Sedan Range

TECHNICAL BULLETIN

Recall R691 –
Incorrect Emission Control Label –
Install Revised Label – U.S. Vehicles

MODEL 1995 MY XJR
VIN 720001-754303

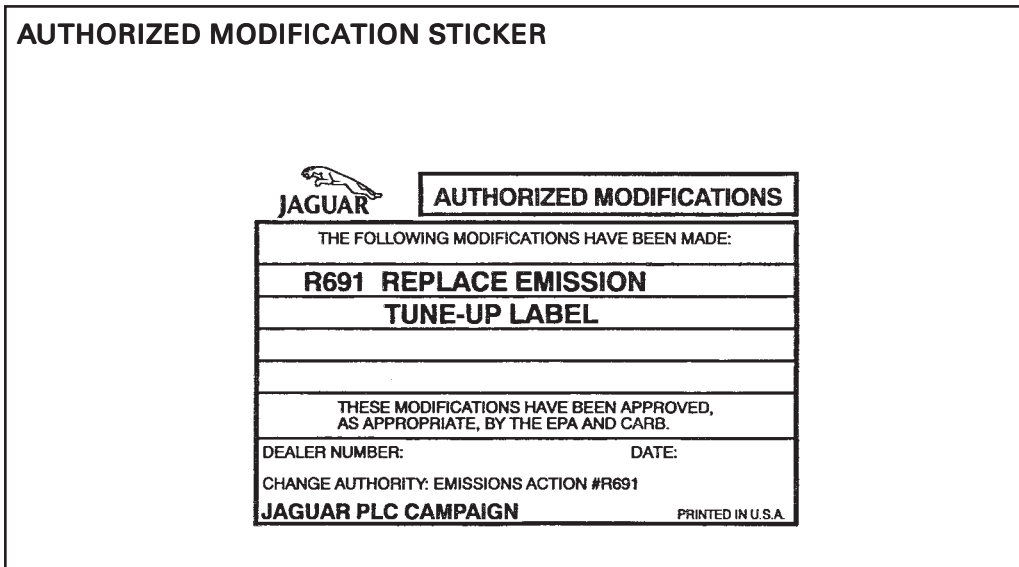
On all 1995 Model Year XJR Sedan Models within the above VIN range, the factory-installed Emission Control Data Label ("Tune-up Label") was incorrectly specified. This label is applied to the crossmember above the radiator, within the engine compartment. 1995 MY XJ6 4.0L Sedan models with naturally-aspirated AJ16 engines are NOT affected.

The existing label implies that the engine is equipped with an Exhaust Gas Recirculation system which is not the case.

Jaguar Cars will contact customers by mail. The necessary replacement labels for this purpose, bearing the correct wording, will be supplied to you by Jaguar Cars.

LOCATION OF EMISSION CONTROL DATA LABEL

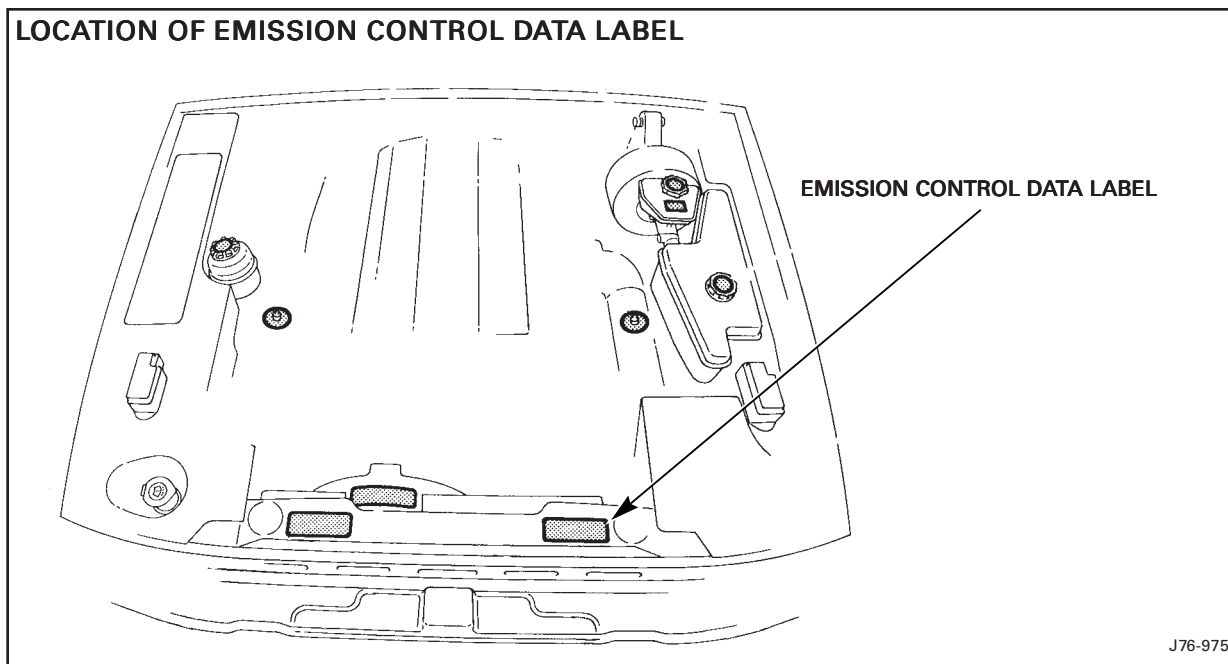
2. Identify the Emission Control Data Label (“Tune-up Label”), located on the left side of the cross panel above the radiator (Illustration 2).
3. Clean off the existing label.
4. Apply the replacement label over the old label.
5. Apply an R691 authorized modification label to the Driver side B-pillar. (This label will immediately indicate to any other Dealer that the vehicle concerned has already been rectified).
